## NOTIFICATION OF LAND USE DECISION

FILE NUMBER: **PUDM25-01**

**LOCATION:** Haymeadow Planned Unit Development (PUD)

**DESCRIPTION OF REQUEST:** A Minor PUD Amendment to the Haymeadow PUD Guide and the Haymeadow Trails Plan to: 1) add minimum lot area standards; 2) add multi-family bicycle parking standards; 3) clarify streetscape standards; and 4) correct other clerical and technical errors in the existing PUD Guide; and 5) make minor corrections to the PUD Trails Plan.

- 4) Proposed Changes (in redline) - Section 3.A.4(c)3.:

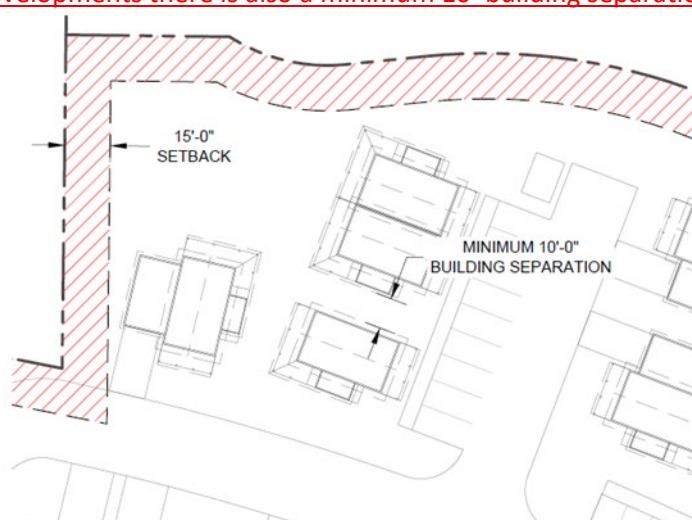
Rear: 10 feet

9) Proposed Changes (in redline) - Section 3.B.3.:

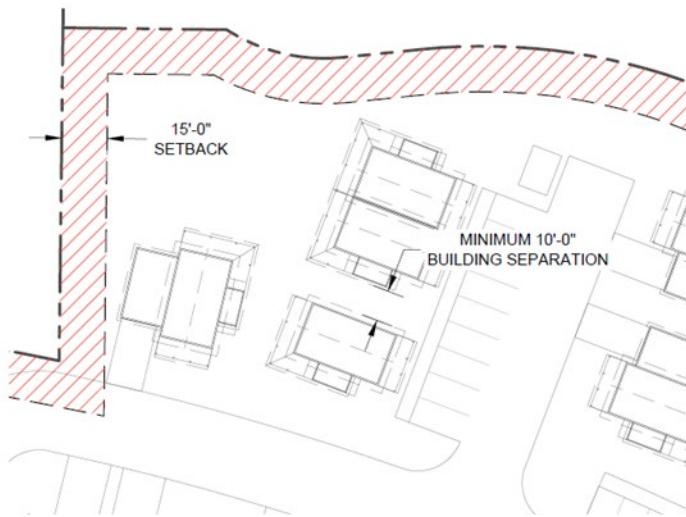
Minimum Lot Area Standards:

- d. Single-family – 5,000 sq.ft.
- e. Duplex (per unit) – 2,500 sq.ft.
- f. Attached Dwellings (per unit) – 1,500 sq.ft.
